Docket Item # 5
BAR CASE # 2008-0112

BAR Meeting
July 23, 2008

ISSUE: Alterations & Signage

LOCATION: 1000 Cameron Street

Figure 4: Existing and proposed windows

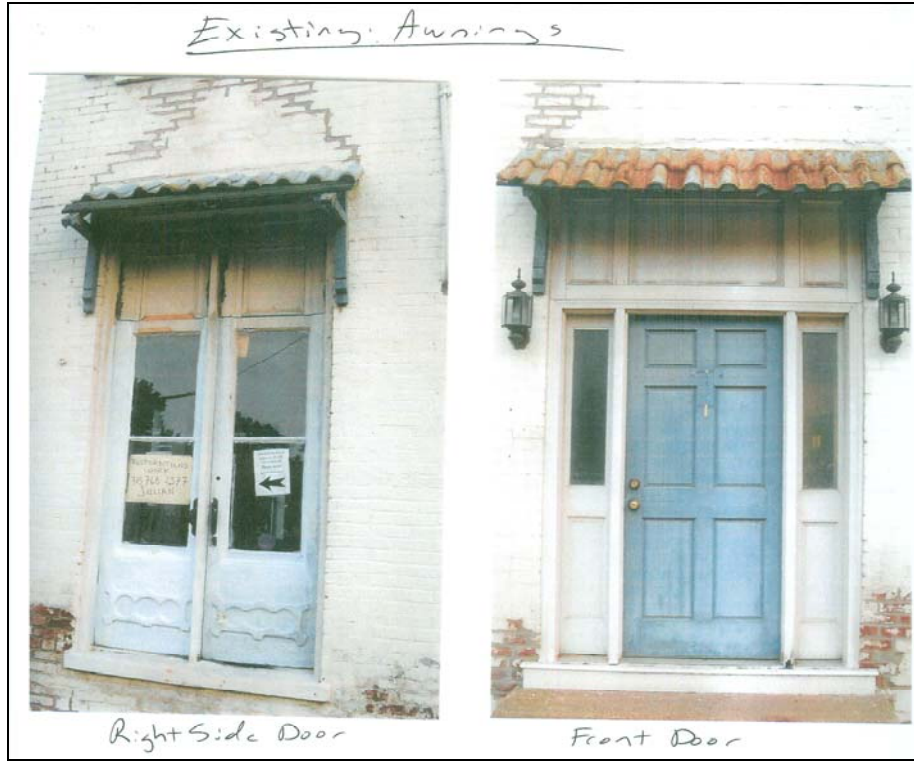
The *Design Guidelines* recommend that all windows on historic properties be single glazed (1 pane of glass) with true divided lights, although the Board has on a number of occasions permitted the use of double pane insulated windows with exterior mullions and interior spacer bars, often in less visible locations. Double insulated windows, like those proposed by the applicant, have a different appearance than historic windows with single glazing. Because windows are such a character-defining feature of a building and this particularly building is highly visible, Staff recommends repair and retention of the historic windows on the first floor if feasible (Staff believes that these single sash windows may be original). Because the *Guidelines* state that “double glazed true divided light wood windows” are acceptable, Staff recommends approval of historically appropriate, two-over-two, true divided light, double insulated, wood windows with fixed exterior muntins and interior spacer bars for the second floor windows.

1. That the applicant work with Staff to determine if the first floor windows can be retained and repaired if possible. If Staff determines the windows cannot be retained, the replacement windows on the first floor must be single-pane, true divided light wood windows with four lights and a fixed sash;

2. That the replacement windows on the second floor may be two-over-two, double insulated wood windows with fixed exterior muntins and interior spacer bars;

Figure 5: Existing awnings

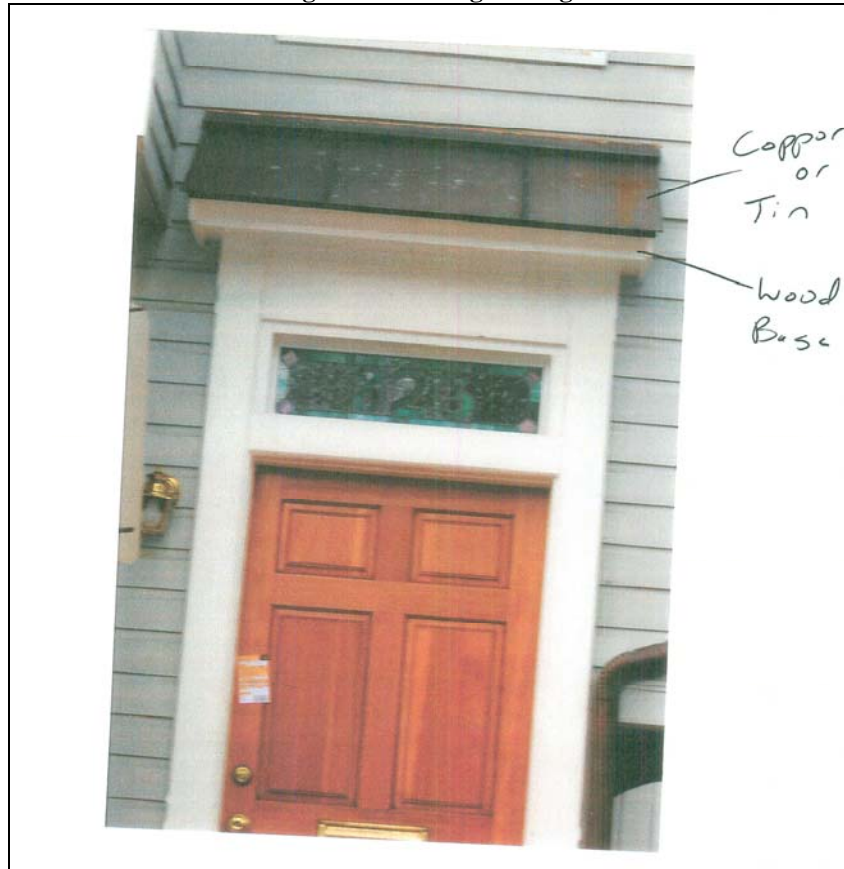
Staff supports the replacement of the Spanish tile door hoods with construction of the standing seam metal door hoods provided that the existing brackets supporting the hood structures be either retained and repaired if possible or replaced-in-kind.

2. That the wood brackets supporting the existing door hoods be retained or repaired if possible, or replaced-in-kind, when the new door hoods are installed;

Figure 8: Proposed type of basement hatch

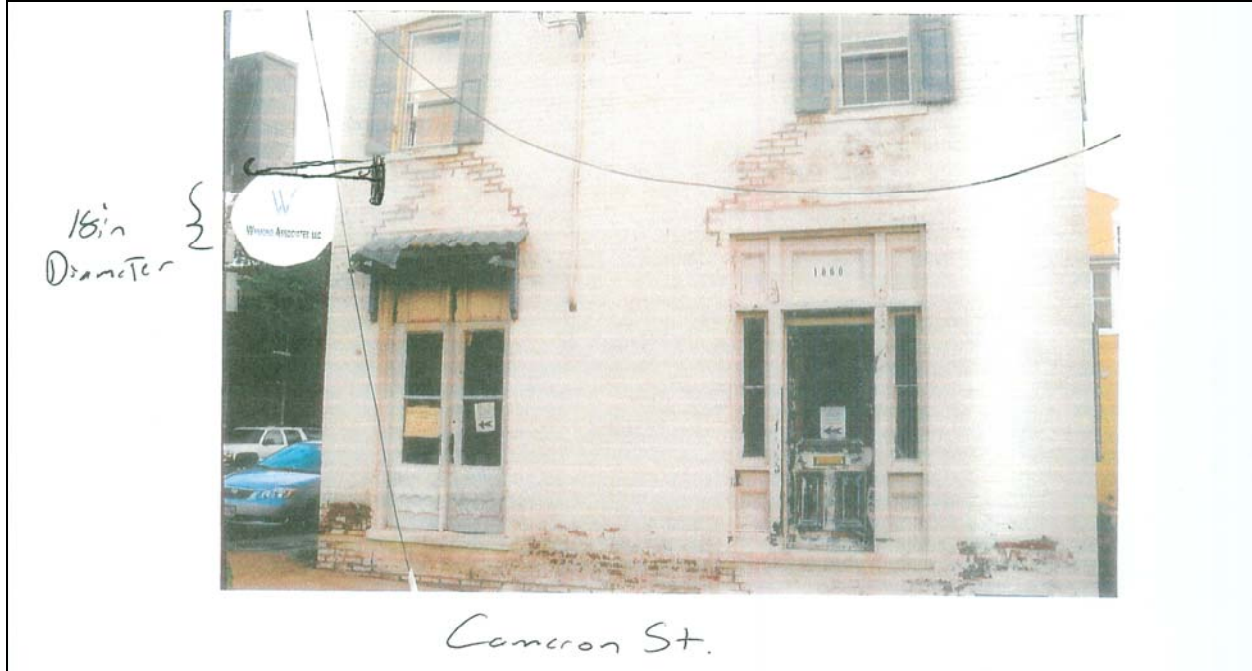
Staff supports the renovation of this historic property, which has fallen into significant disrepair over the last few years. Staff finds the majority of the proposed alterations – the stoop, basement hatch and repair of the damaged sills – to be appropriate and in conformance with the *Design Guidelines* for alterations. However, some of the alterations warrant further discussion.

Figure 9: Proposed hanging sign

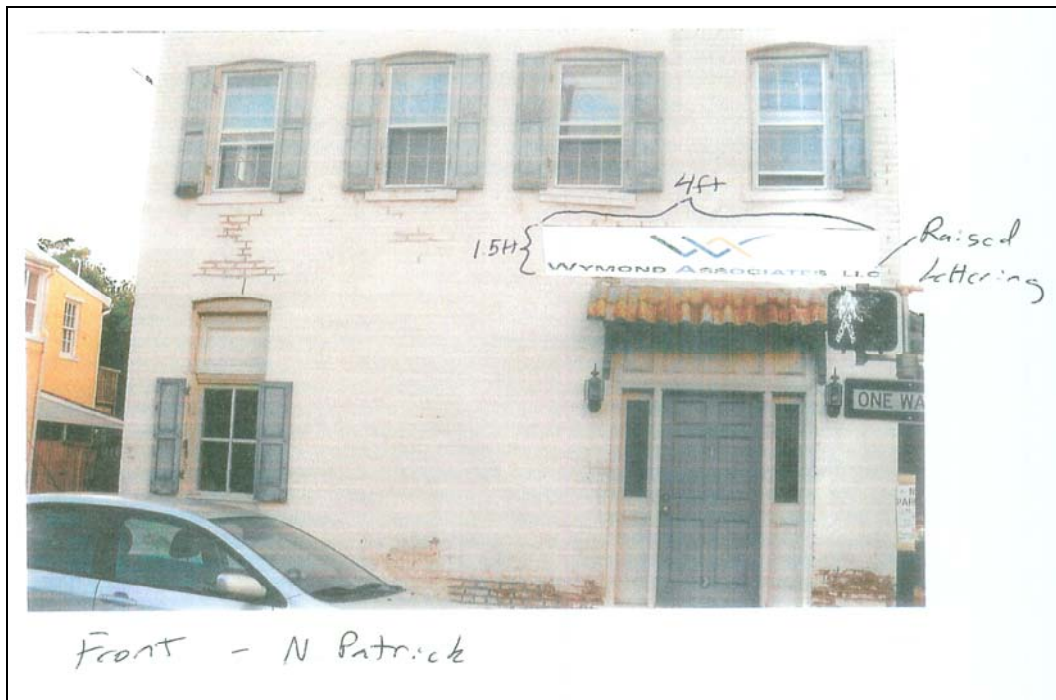
Although the *Design Guidelines* state that, “generally, only one sign per business is appropriate,” Staff believes that two signs are acceptable in this particular case because the building has two street frontages, as a corner building. However, Staff does object to the use of high density foam signs for this historic building and instead recommends that the applicant install either a wood or MDO (Medium Density Overlay plywood) signs. When applying for a sign permit the applicant should also include specifications for the metal bracket, which should be mounted into the mortar joints and not the historic brick.

- F-1 The applicant shall obtain a sign permit for the proposed sign and/ or wall lettering.
- C-1 Projecting, hanging signs must comply with USBC [H103-H107, H112] for type of materials, maximum projection, vertical clearance below all parts of the sign, and additional loads.

3. That the signs be constructed of wood or MDO plywood;
4. That the existing shutters may be retained and repaired, or replaced with operable wood panel shutters, sized to fit the openings; and,
